Hi-Fi Products  
**Service Bulletin**

**Model:** HCD-H1500

**No. 302**

**Subject:** High Wow and Flutter

Fig. 1

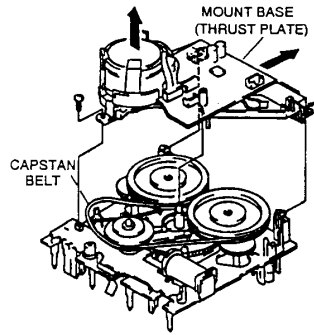
- Remove the mount base (thrust plate) and the capstan belt (fig. 1).
- Release the two hooks indicated by the arrows, and remove the leaf switch board. Be careful not to cut the lead wire of the plunger (fig. 2).

Fig. 5

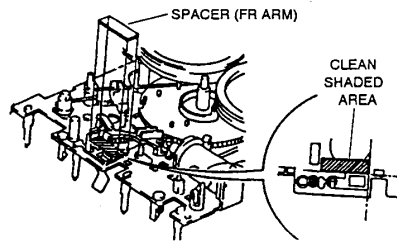
- Lift up the flywheel by hand and remove the lever (FR arm) assembly (fig. 3).
- Lift up the slider (brake plate) in the arrowed direction (fig. 4).
- Stick the spacer (FR arm) to the shaded area of the chassis after cleaning the area with alcohol (fig. 5).

Fig. 7

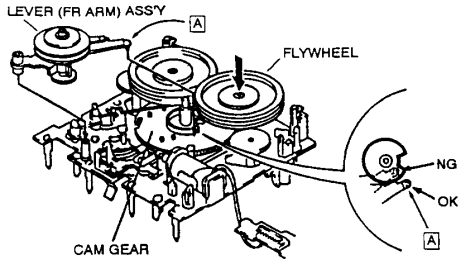
- Reposition the slider (brake plate) in the arrowed direction. Make sure that the twisted coil spring is not out of position (fig. 6).
- Install the new lever (FR arm) assembly while lifting up the flywheel assembly by hand. Be sure to position the A portion of the lever (FR arm) assembly beside the cam gear (fig. 7).

Fig. 9

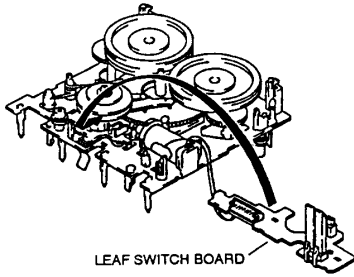
- Install the washer (fig. 8).
- Reinstall the leaf switch board. Route the lead wire of the plunger so that it does not touch the moving part (fig. 9).

Fig. 13

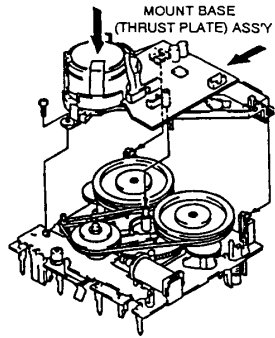
- Reinstall the mount base (thrust plate) assembly (fig. 13).
- Place the capstan belt on the capstan motor pulley. Do not twist the capstan belt (fig. 14).
